MEMORANDUM

RE: Response to Comments on NOI for DEP #CE 204-0991, The Reconstruction of Foster Street in Littleton, MA

RE: Stormwater Analysis
Reconstruction of Foster Street Project (MassDOT Project #609054)
MassDEP File #204-0991

Existing and Proposed Watershed Maps

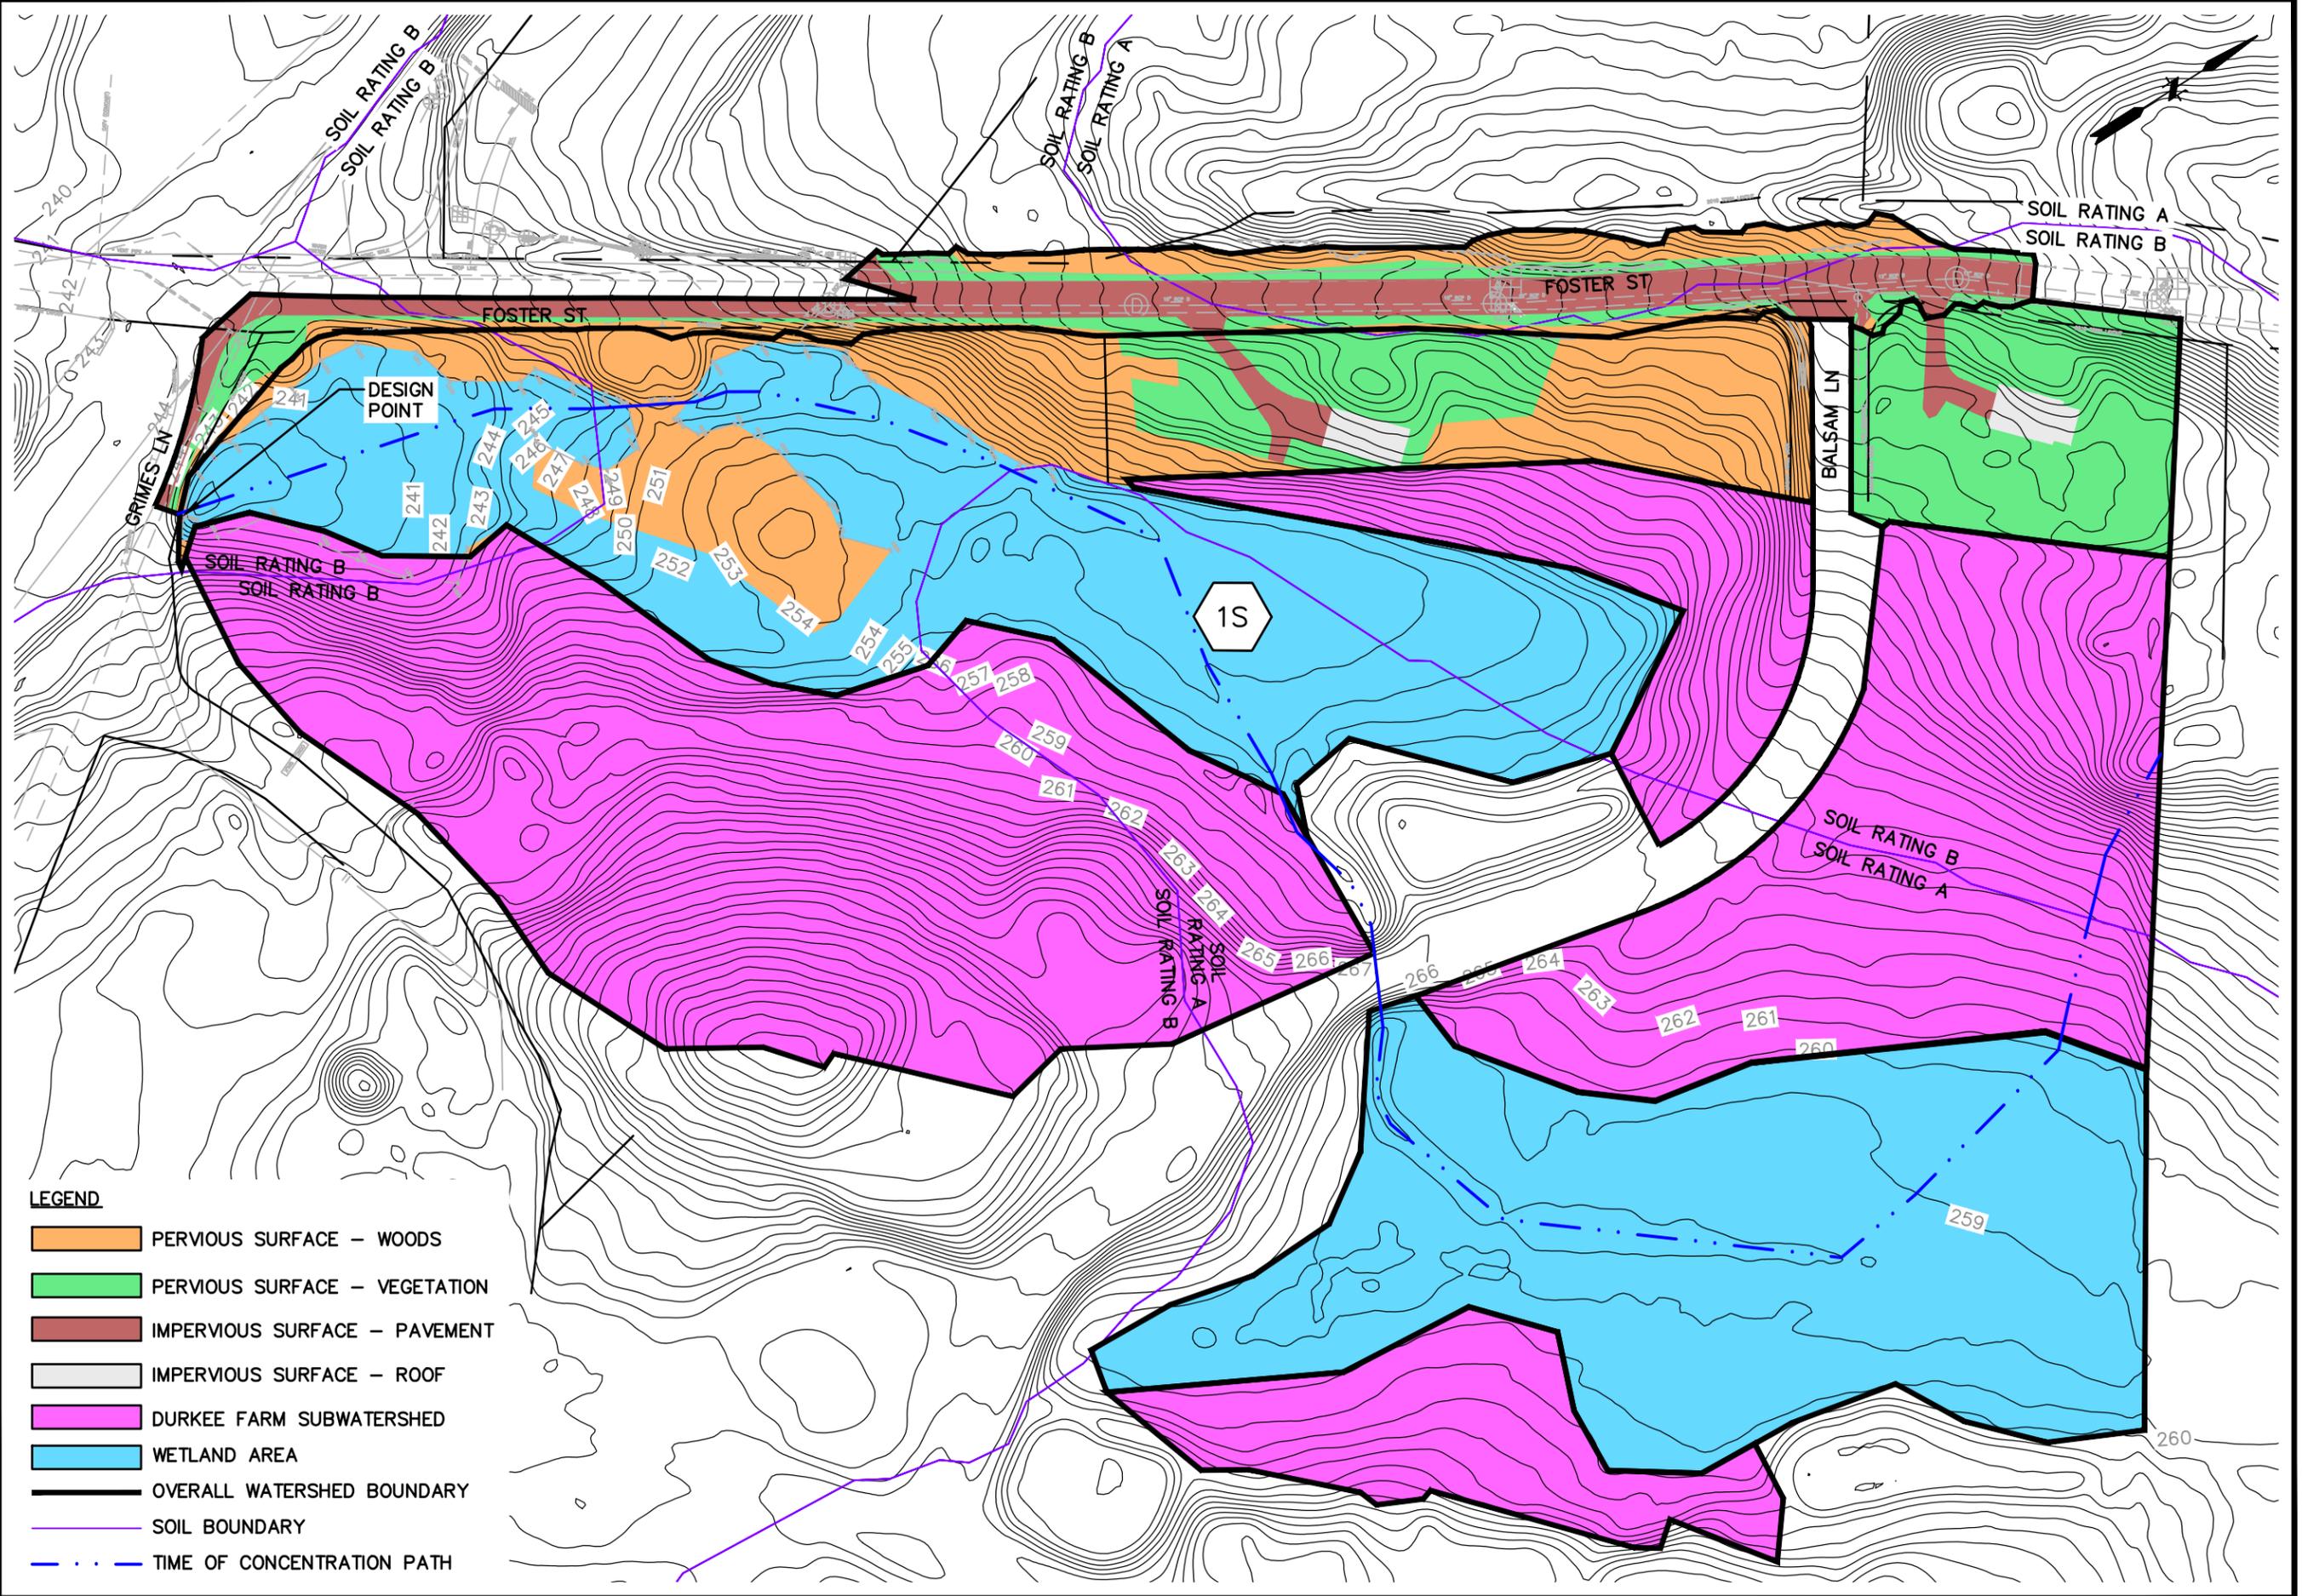
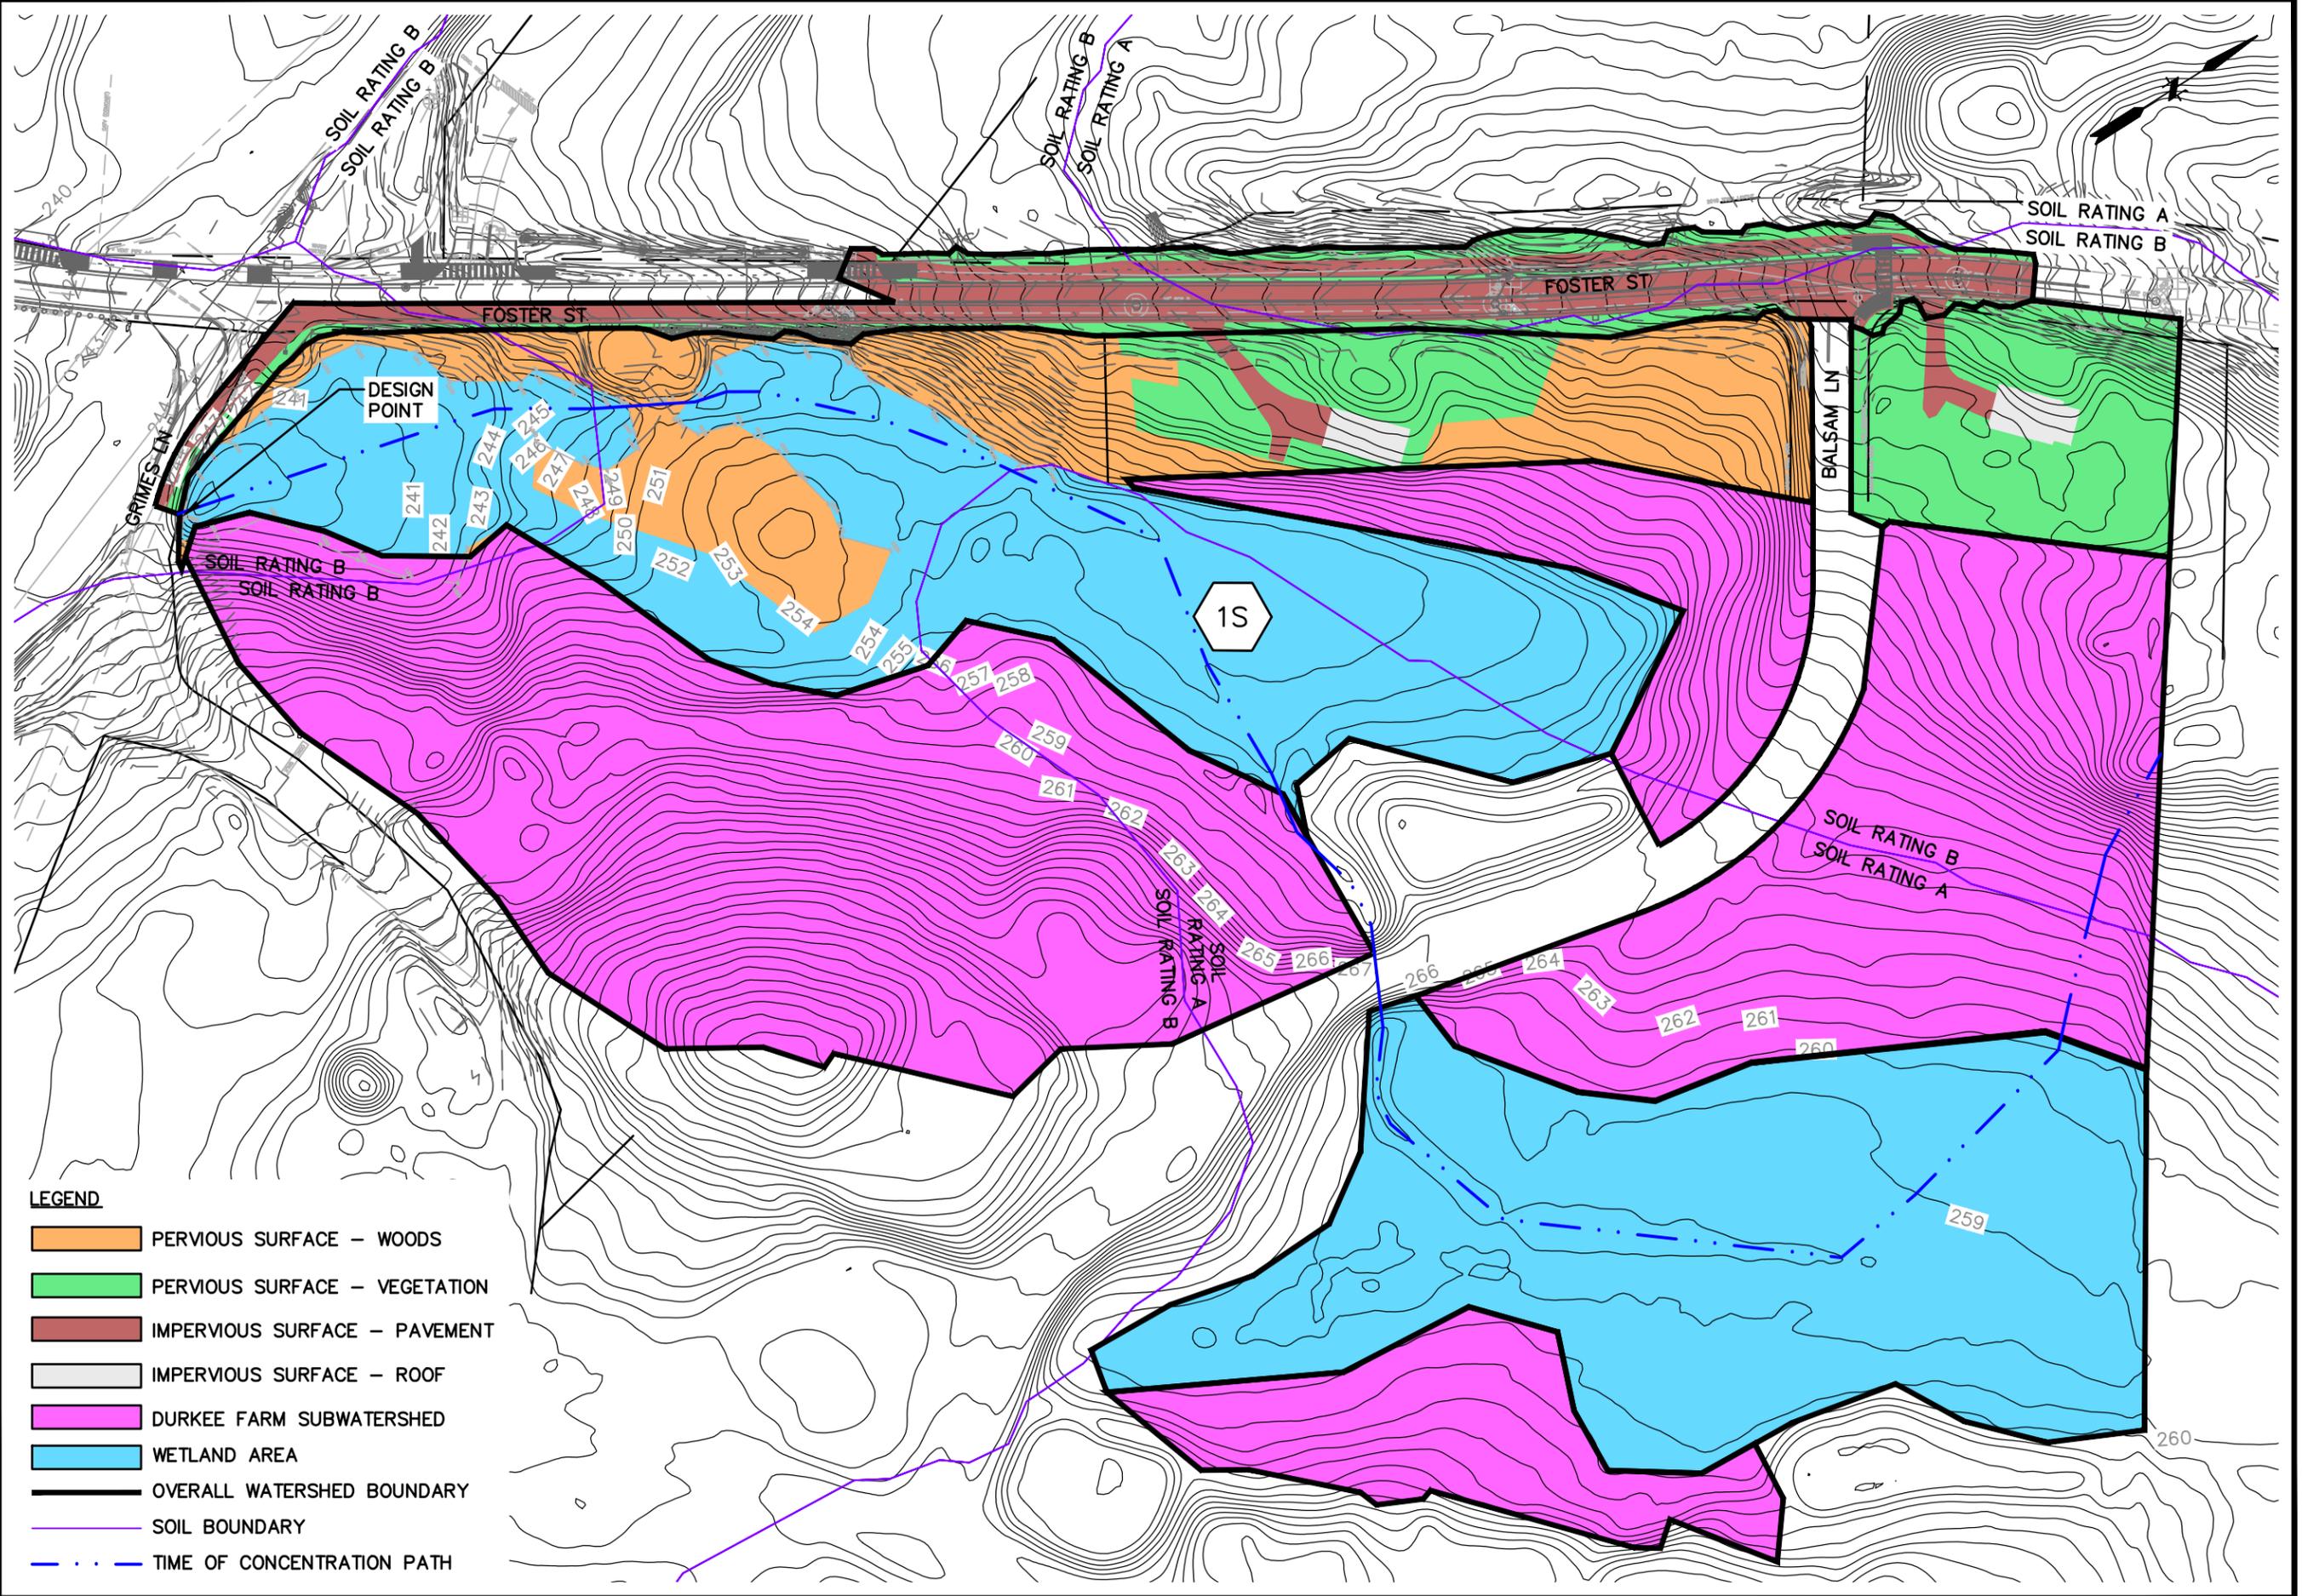
- Commissioners identified that water was flowing towards the embankment from the southeast. Commissioners suggested that F&O investigate the source and flow rates of that water and determine what impact, if any, it might have on the post-construction embankments.

- The realignment of Grimes Lane will result in fill of low-lying land adjacent to the wetland that currently provides stormwater storage during peak flows within the 50 No Disturb Zone. Commissioners asked how the removal of this stormwater storage would be compensated for in the project limits as planned and furthermore as is realistic once the extents of work are adjusted to represent a realistic condition. Commissioners identified that a stormwater model may be necessary.

F&O Response #1: Based on our review, it appears that the source of this water is likely from the draining of the detention basins from Durkee Farms development and or residual stormwater flow from upgradient areas of this wetland system. Considering the amount of rainfall we have experienced this fall; wetland areas of this nature commonly have water flowing through them well after a storm event has ended. F&O performed a hydrologic analysis of the proposed project and determined that the proposed increase in impervious area has a negligible effect on the amount of stormwater runoff flowing into the wetland at 260 Foster Street. The hydrologic analysis is provided in Attachment 1.

F&O Response #2: F&O reviewed the topography of the wetland at 260 Foster Street to determine if the project's impacts related to fill within and adjacent to the wetland area would affect the wetland's ability to store stormwater. Utilizing the 1-foot contour layer available through the MassGIS MassMapper tool (<https://maps.massgis.digital.mass.gov/MassMapper/MassMapper.html>), the topography of the wetland generally slopes from an elevation of 257 at the outlet of the culvert under Balsam Lane to elevation 239 at the southern end before entering the stone culvert's inlet (design point) at elevation 236.38 located underneath Grimes Lane. The topography does not depict significant berms or depressions in the vicinity of the proposed fill.

Although the wetland may have some localized low points, it is our engineering judgement that the wetland area does not provide any significant storage for stormwater. Therefore, the proposed fill will not adversely affect the wetland's ability to convey stormwater. The hydrologic analysis is provided in Attachment 1.

Additionally, the proposed areas of fill are not in BLSF or a FEMA floodway. It would be unusual to excavate for compensatory storage for fill not located in BLSF or floodways for a limited project.

**CONCRETE BLOCK
 LEACHING BASIN**

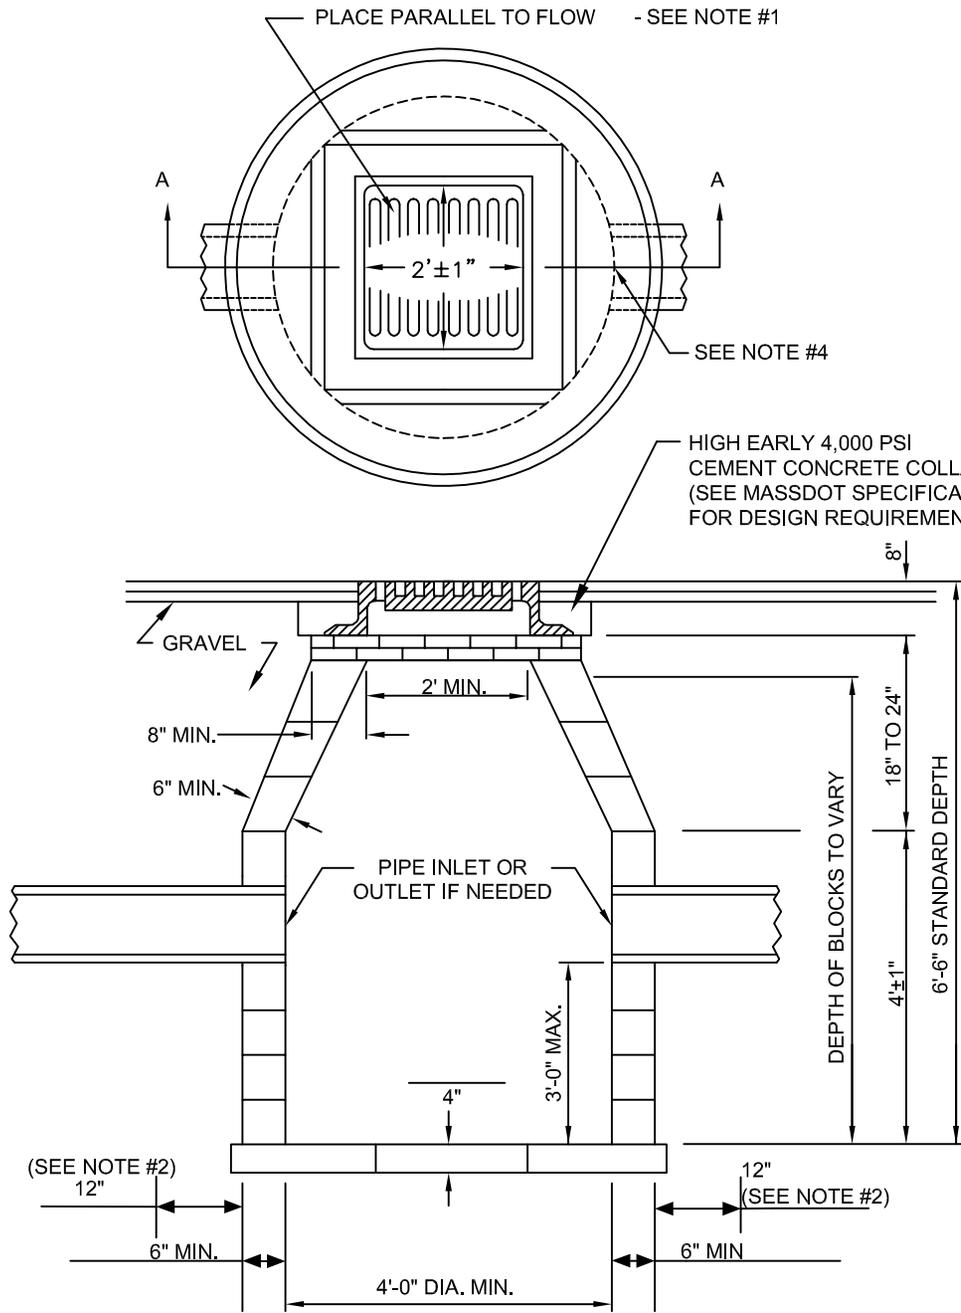
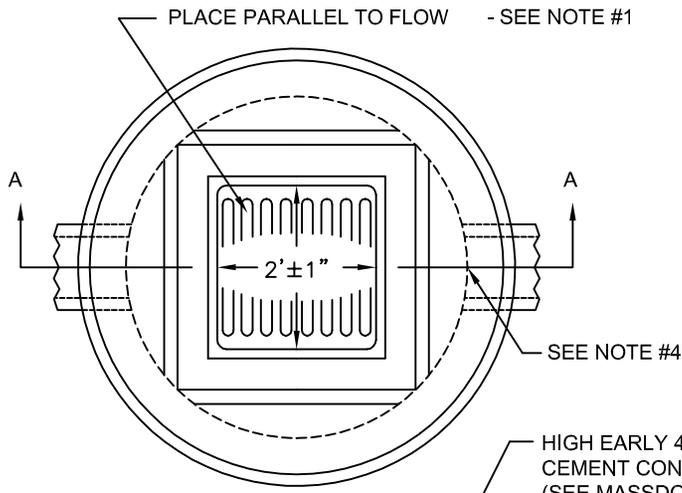
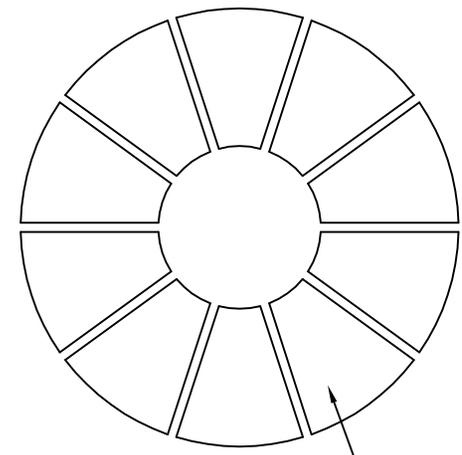
- Commissioners expressed concern that leaching catch basins less capable of managing high flow events and may have less value mitigating stormwater flows during design storms.

F&O Response #3: We accept the commissioner's statement; however the leaching catch basins will still provide helpful infiltration. If the storage capacity of the leaching catch basins is exceeded, stormwater will bypass the inlet of the leaching catch basins. None of the leaching catch basins are located at low points therefore there is no risk of ponding at the leaching catch basins. Any stormwater

that bypasses the leaching catch basins will continue to the existing low points of the project where traditional deep sump catch basins are located. A detail of the standard MassDOT Leaching catch basin is provided in Attachment 2.
